**La Jolla Shores Planned District Advisory Board (LJSPDAB)
APPLICANT PROJECT INFORMATION FORM**

- Project description: _____New two-story SFD, 5284 sf plus 912 sf garage, pool and site stabilization_____
- Please indicate the action you are seeking from the Advisory Board:

RE: **Site Development Plans**
Cycle Issues –**Responses**
Project Number: **PRJ-1104699**

Subject: PRJ-1104699 Livewire, La Jolla Scenic Dr- 2nd Assessment Letter
Internal Order No. 24009702; La Jolla Community Plan Area

SHEET NAME
NEIGHBORHOOD
ELEVATIONS &
PHOTGRAPHIC
SURVEY

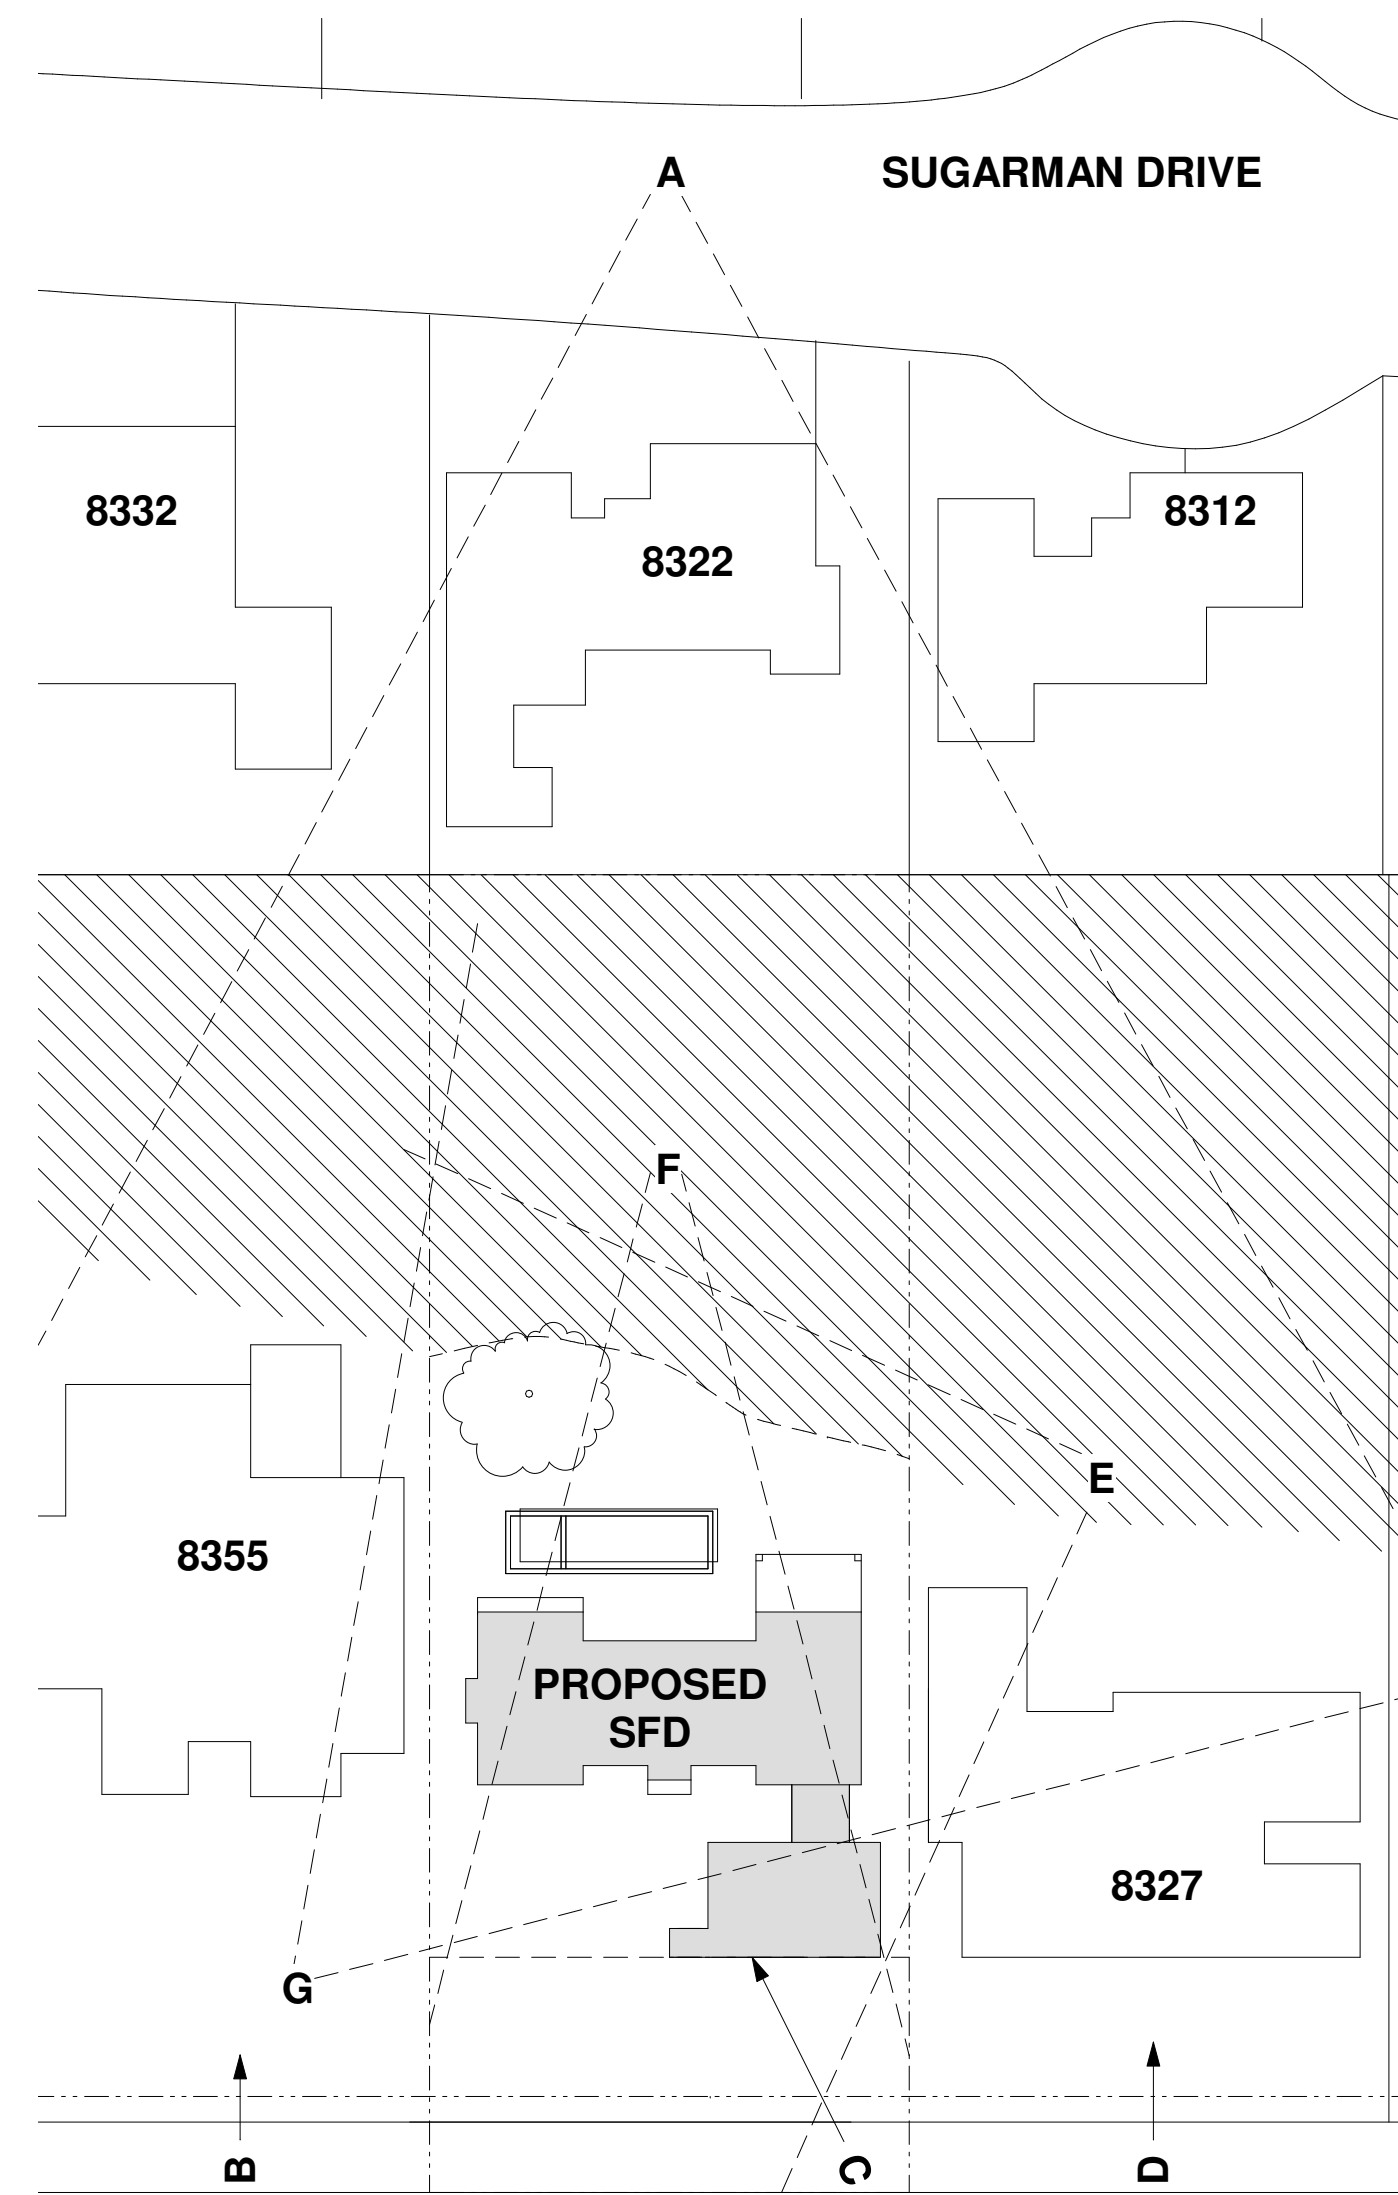
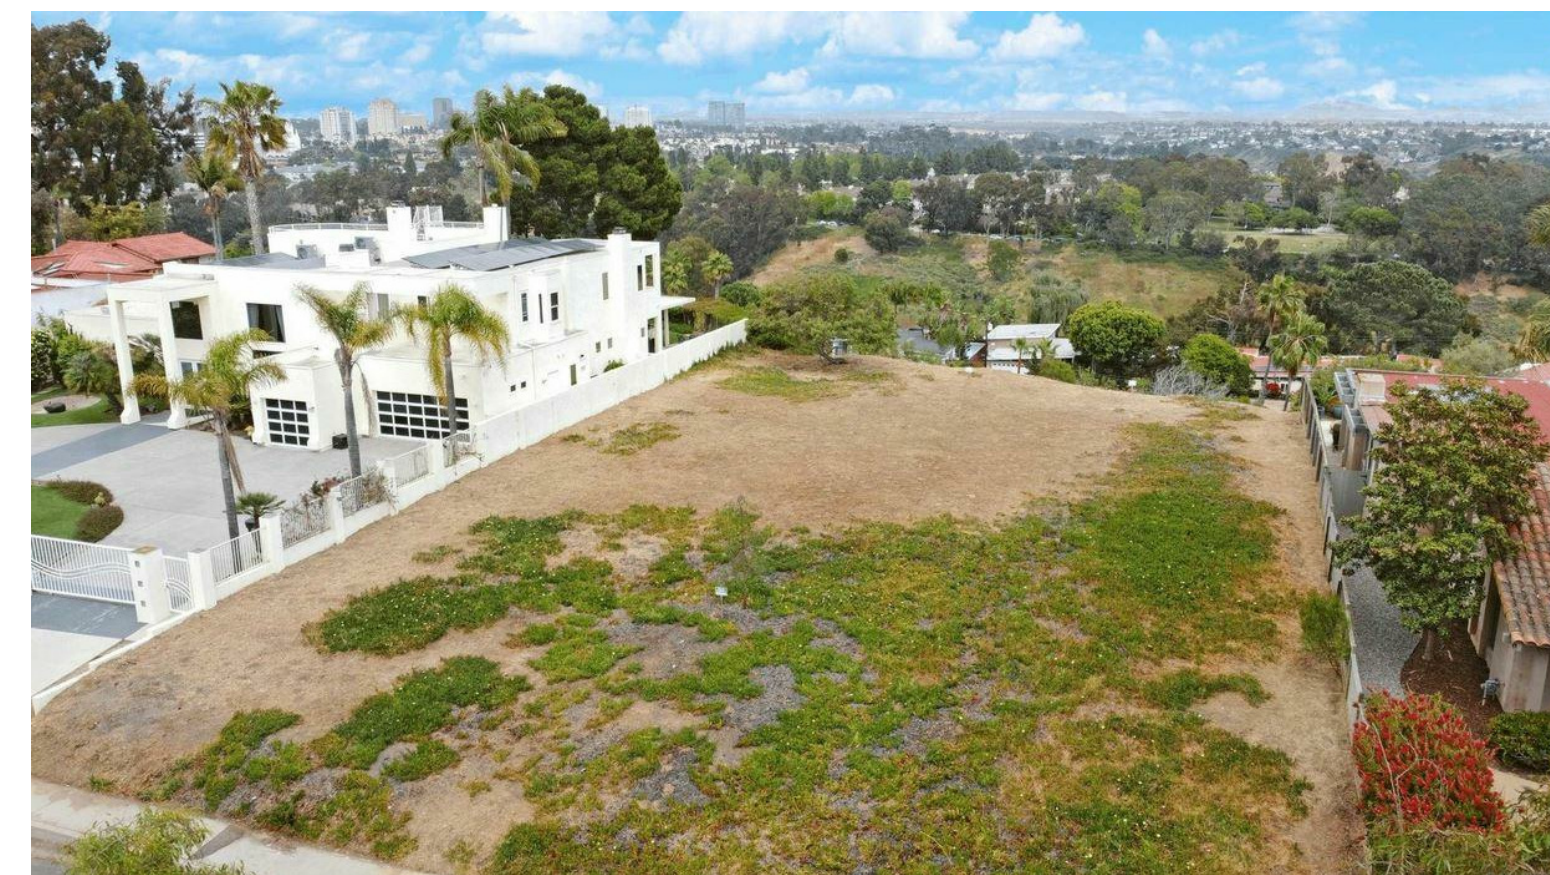
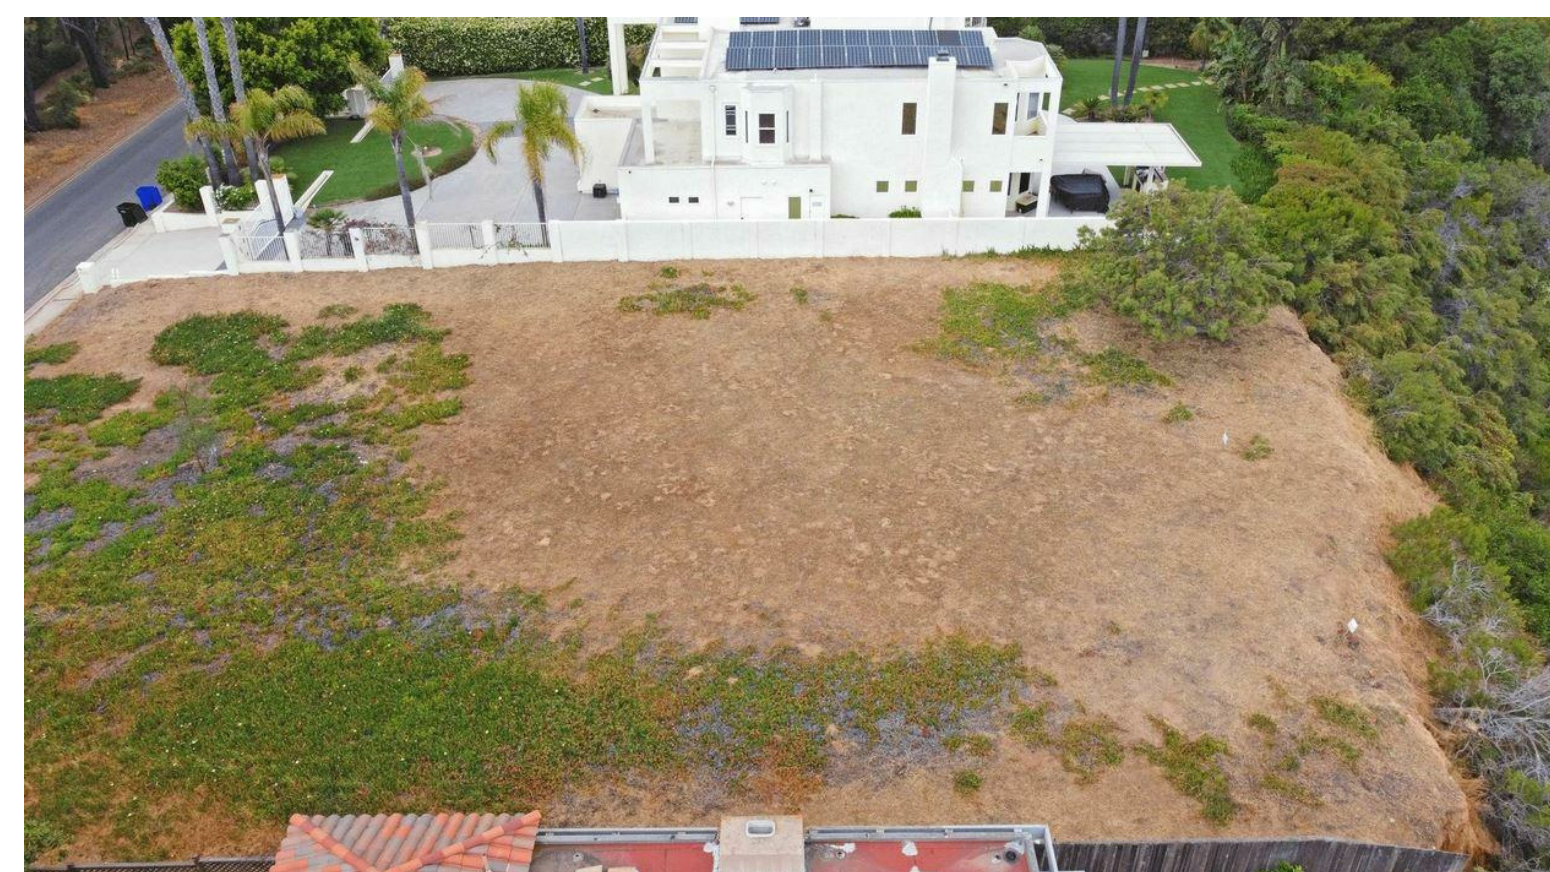
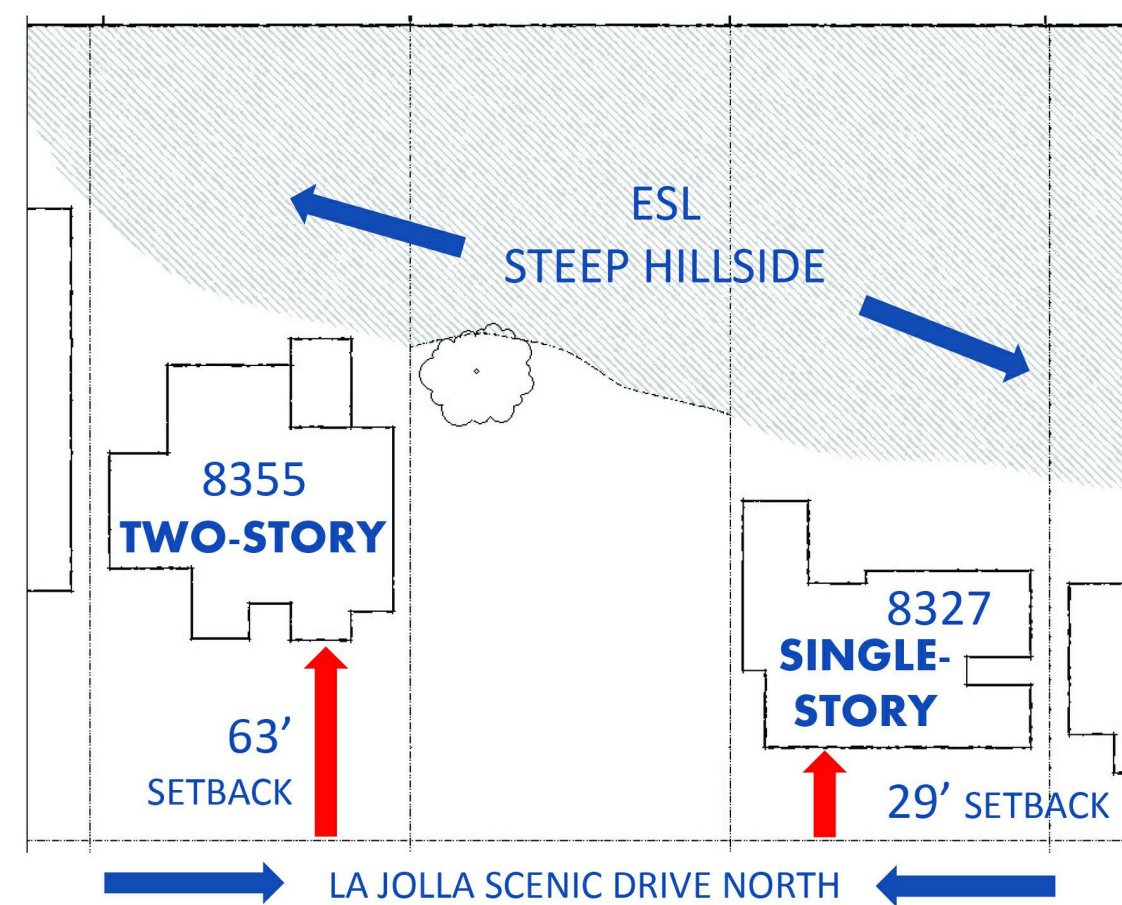
8. Per Building & Zoning Plat Map 252-1695, there is a 29' established front setback. Please label this as "established setback" on the site plan.
9. On the neighborhood survey, please add the side yard setbacks to: 8332, 8322, 8312, 8302, and 8298 Sugarman Drive.

b. (9) Side yard setbacks added to neighborhood survey
